Access Compliance Report

Public Rights-of-Way

Intersection ID: 27903	Main Street: ALEXANDER_MILL_DR	Cross Street: BALLANTYNE_COUNTRY_CLUB_DR	Location: NE
ADA ID: D26912C1712F	Ramp Type: Perp	Initial Pass/Fail: Fail	Overall Compliance: No
		Severity Score: 25

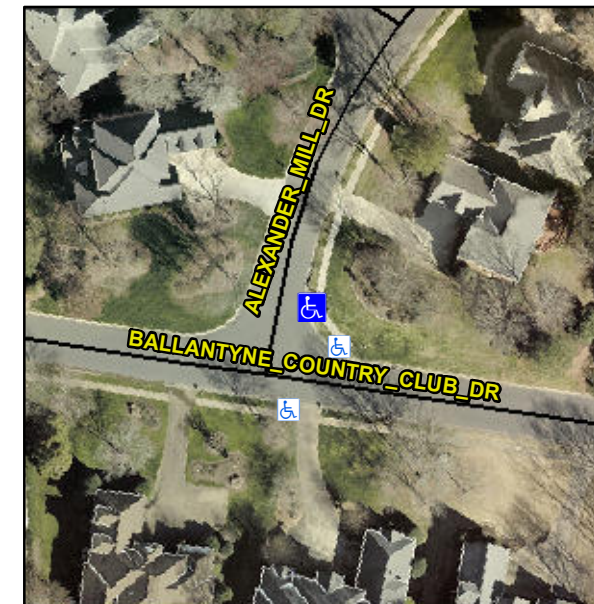
Not Found, R304.5.3

Compliance	Description	Data	Compliance	Description	Data
N/A	Ramp Length (in)	43.0	Yes	Ramp Slope (%)	7.0
Yes	Ramp Width (in)	48.0	No	Ramp XSlope (%)	7.1
N/A	Flare Type LT	N/A	N/A	Flare Type RT	N/A
N/A	Flare Slope LT (%)	N/A	N/A	Flare Slope RT (%)	N/A
N/A	Flare Traversable LT?	N/A	N/A	Flare Traversable RT?	N/A
N/A	Landing Length (in)	N/A	N/A	DWS Provided?	N/A
N/A	Landing Width (in)	N/A	N/A	DWS Contrast?	N/A
N/A	Landing Slope (%)	N/A	N/A	DWS Length (in)	N/A
N/A	Landing X Slope (%)	N/A	N/A	DWS Full Width?	N/A
N/A	Landing Curb? (Y/N)	N/A	N/A	DWS Offset (in)	N/A
N/A	Shared Landing?	N/A			
N/A	Gutter Ponding?	N/A	N/A	Gutter Slope (%)	N/A
N/A	Gutter Lip Ht (in)	N/A	N/A	Gutter X Slope (%)	N/A
N/A	Painted X Walk1?	No	N/A	Painted X Walk2?	N/A
	X Walk 1 Direction	To NW		X Walk 2 Direction	N/A
N/A	X Walk 1 Width (in)	N/A	N/A	X Walk 2 Width (in)	N/A
	X Walk 1 Slope (%)	1.7		X Walk 2 Slope (%)	N/A
	X Walk 1 X Slope (%)	2.5		X Walk 2 X Slope (%)	N/A

Remove & Replace Entire Ramp.
